From: Lynch, Joanne <Joanne.Lynch@aecom.com>
Sent: Monday, February 22, 2016 2:02 PM
To: Battaglia, Frank
Cc: Joseph Guarnaccia; Hellerich, Lucas; Henderson, Rory; Hansel, Kelly; Atter, Steve
Subject: Former Ciba-Geigy Property, 180 Mill St, Cranston, RI - CMS DRAFT Final Text & Figure Revisions - For Your Review and Approval
Attachments: BASF_CMS_DRAFT_Final 2016-02-22.docx; Figure_18A_Soil_Selected_Remedy.pdf; Figure_18B_Soil_Selected_Remedy.pdf

Frank – Attached is the revised text of the BASF Corrective Measures Study for 180 Mill St, Cranston, RI in red-line-strike-out format. The text reflects changes in response to EPA comments provided to BASF on 1/29/16. Below is a memorandum from Joe Guarnaccia at BASF that explains the text modifications. Please do not hesitate to contact me if you have any comments or questions. Best Regards, Joanne

This is a CMS revision that addresses the issues you raised with me on 1/29 when we spoke. Specifically, we altered the Executive Summary and Section 6 and some figures to add the following information:

Figure 18A and Figure 18B show two conceptual scenarios of the proposed excavation and extent of the high-occupancy cover, and Inset Figure 1 provides a conceptual regrading and native habitat enhancement plan associated with the FPA high occupancy cover remedy.

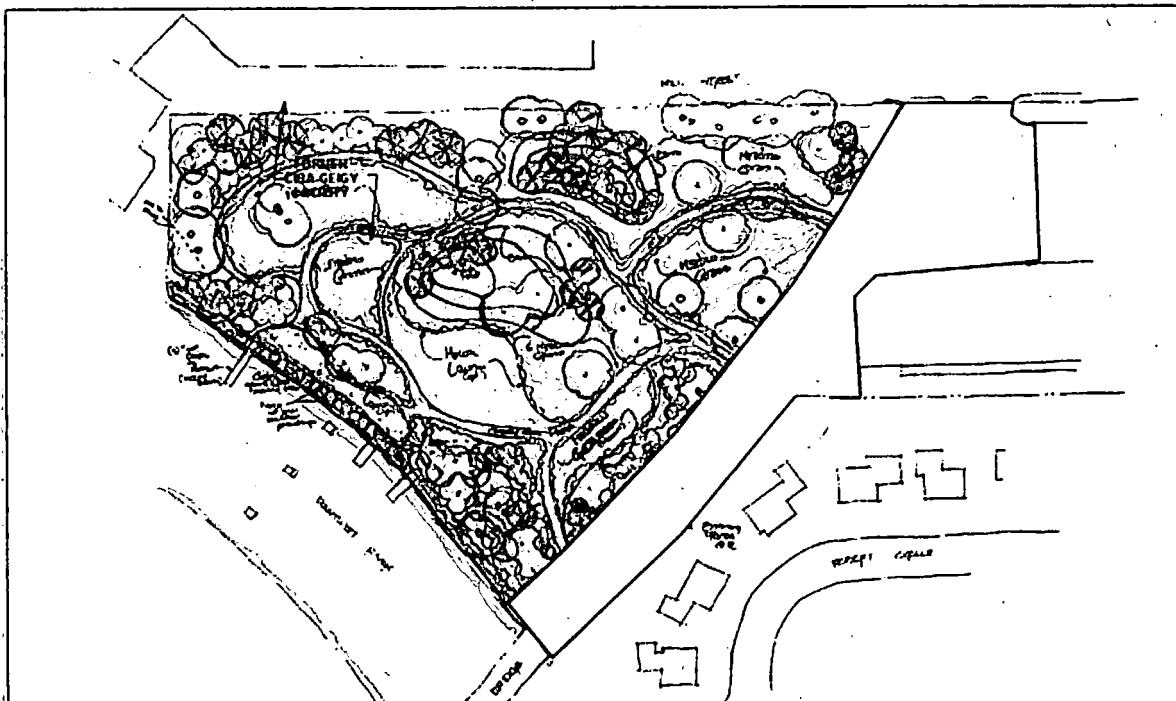
- c. Details on the cap monitoring are needed.
2. River lot, soil – Detail added:
 - a. Reference that the remedy will follow TSCA rules and meet RIDEM criteria. 4 Phases: [1] Remove >50ppm and verification sampling; [2] Remove >10ppm and verification sampling; [3] Consolidate, put down witness barrier, and cap >1ppm. Where cleared < 1ppm, confirmatory sampling. The cap will be completed to support diverse upland habitat (an example added); [4] ELUR to be approved by the DEM.

- **Phase I - Excavation, verification sampling and offsite disposal of all TSCA-classified soil (i.e., soil impacted with greater than 50 ppm of PCBs).** See Figure 18A and Figure 18B for two scenarios showing the target areas. As the targeted volumes are removed, a TSCA-conforming verification sampling plan will be implemented to ensure that the 50 ppm threshold has been achieved. Before excavation, disposal will be coordinated with transport contractors and disposal facilities equipped to accept the estimated volume of TSCA waste [currently 1,170 cubic yards (CY)]. A sampling plan to confirm soils with PCBs greater than 50 ppm have been removed will be included in a future design.

- **Phase II - Excavation, verification sampling and offsite disposal of all soil impacted with greater than 10 ppm of PCBs (i.e., the EPA requirement to allow for a high-occupancy reuse scenario).** See Figure 18A and Figure 18B for the conceptual target areas. As the targeted volumes are removed, a TSCA-conforming verification sampling plan will be implemented to ensure that the 10 ppm threshold has been achieved. Before excavation, disposal will be coordinated with transport contractors and disposal facilities equipped to accept the estimated volume of non-hazardous waste containing PCBs less than 50 ppm [currently 5,100 CY]. Disposal will be coordinated with transport contractors and disposal facilities equipped to accept up to 5,100 CY of non-hazardous waste containing PCBs less than 50 ppm. A sampling plan to confirm soils with PCBs greater than 10 ppm have been removed will be included in a future design.
